6.0 Design Improvements

This section describes the key design improvements made to address the design issues raised in relation to the November 2017 Stage 1 State Significant Development application submission. This includes the outcomes of the design refinement workshops held with the Department of Planning & Environment and their advisor Professor Peter Webber, summarised in Section 5.2 of this report.

Fig. 9. Design Improvement Summary

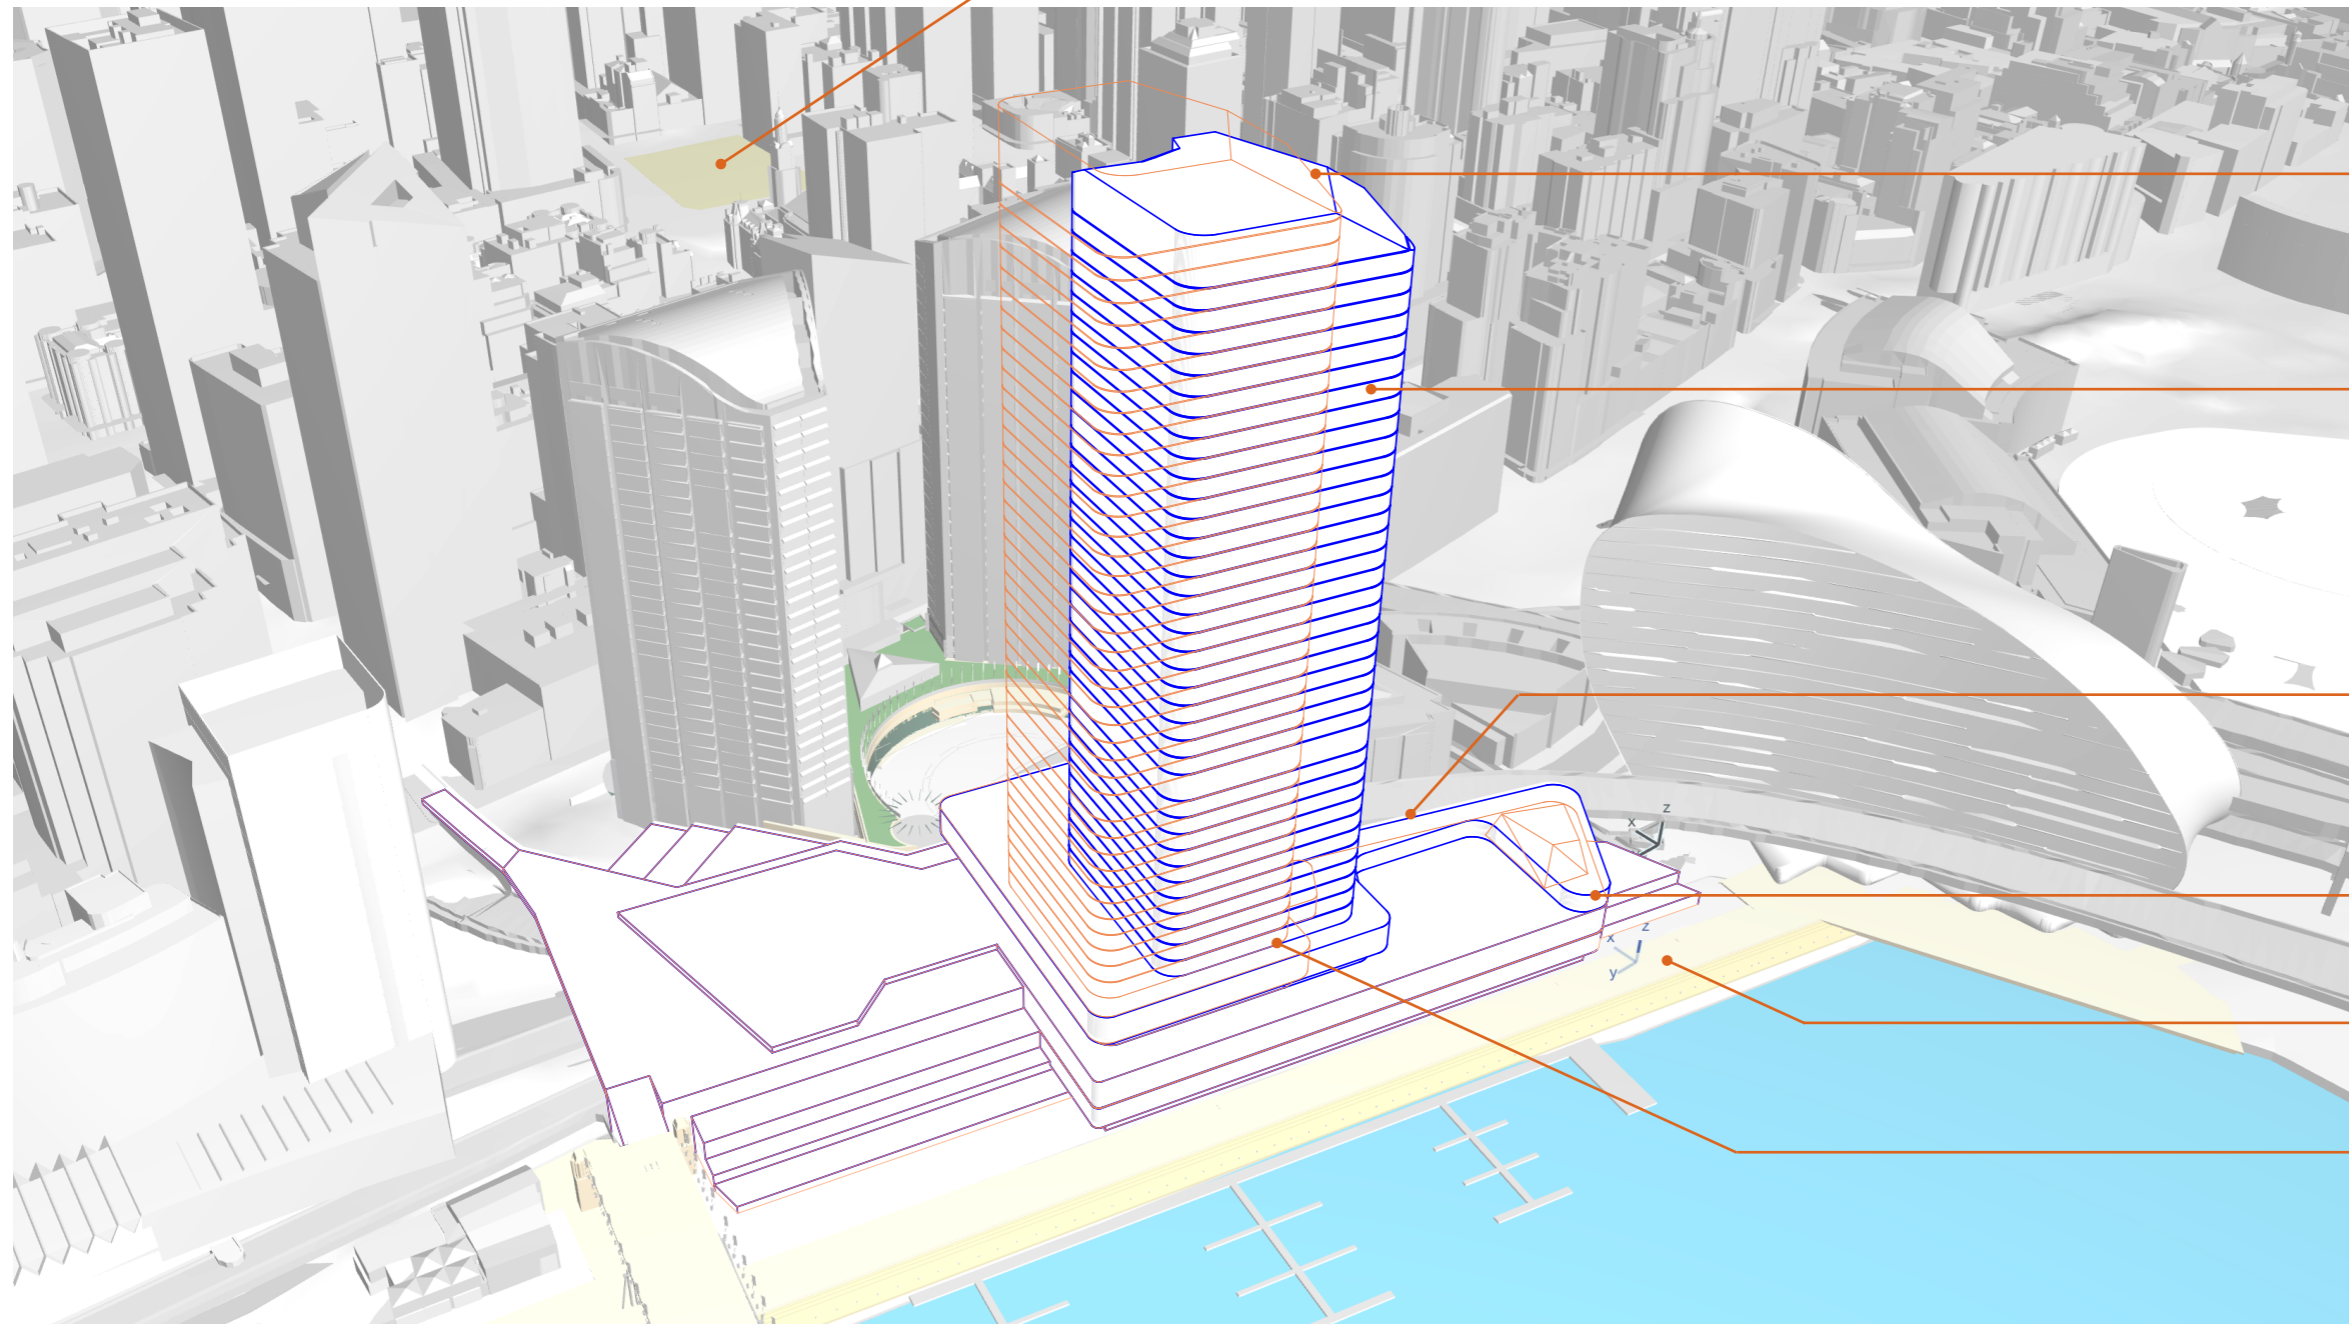
Town Hall Square Overshadowing reduction

Tower height reduction from RL 195 to RL 183

Revised envelope to allow a tower position 15m further south. Massing to be developed and refined by design competition architects

Increased built form separation between the southern public space and the Western Distributor

Southern podium flexibility to improve building perception at the ground plane

No tower overshadowing to the 11.6m promenade zone 11 am - 2pm mid winter

Setback from promenade increased by 2m from 6m minimum / 8m average to 8m minimum / 10m average

Fig. 10. Tower height reduction

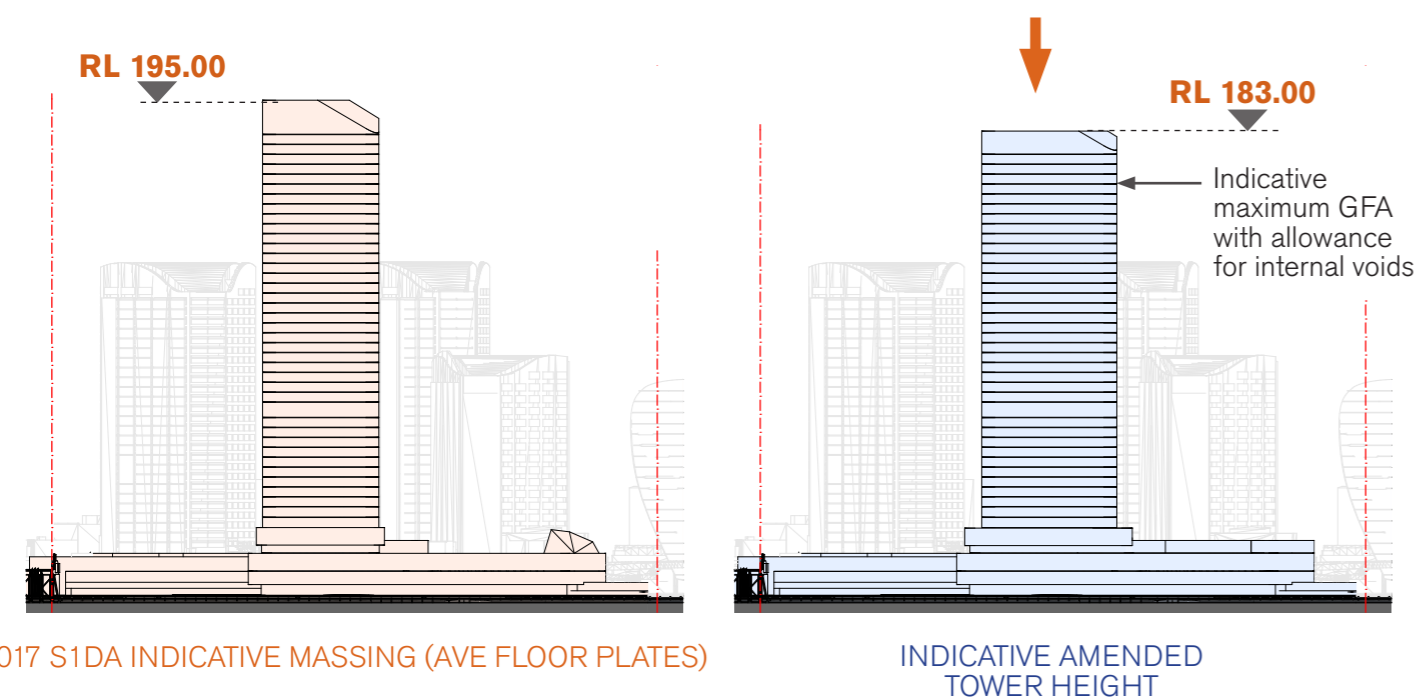
The envelope and maximum building height have been reduced from RL 235m to RL 195m in the November 2017 amended submission, and further reduced in this revised proposal to RL183m. The reduction in tower height improves the building fit within context and reduces Town Hall Square overshadowing impacts.

The height of RL 183 was the resulting limit in height reduction based on the following key constraints;

- Acceptable tower slenderness ratio while maintaining commercial requirements of floor plate sizes and overall area. Testing of further reductions in height resulted in shorter and wider buildings that increased the perception of bulk and scale when viewed from around Cockle Bay.
- Building massing that provides the best balance of private residential view sharing. Increasing slenderness reduces the visual impact of the massing through view corridors to the east and south.

A 12m reduction in height (in addition to the 40m reduction from the original S1DA submission) will relate more closely to the current Darling Park Tower complex, as well as the broader CBD context. RL183 is the result of a series of design review studies to determine the best balance between minimising height, maintaining an acceptable tower slenderness, and creating a commercially feasible project that can deliver the public space outcomes of the original vision.

The reduction in height to RL183 will reduce the visual presence of the tower when viewed from around Cockle Bay, while maintaining allowance for an acceptable slenderness ratio. Further reductions in height and subsequent increase in width would result in increased occupation of private view corridors from residential buildings such as the Astoria apartments, Millennium Towers and 60 Bathurst St. Refer to the Visual Impact Assessment by Ethos Urban and Virtual Ideas which addresses the anticipated impact of the revised Concept Envelope as it is now proposed, as well as an indicative building massing.

The reduction in height significantly reduces the impact of overshadowing on the proposed Town Hall Square, with analysis indicating a minor (0.06%) increase in annual average overshadowing across the square. Further details on the overshadowing impact on Town Hall Square are provided later in this report.
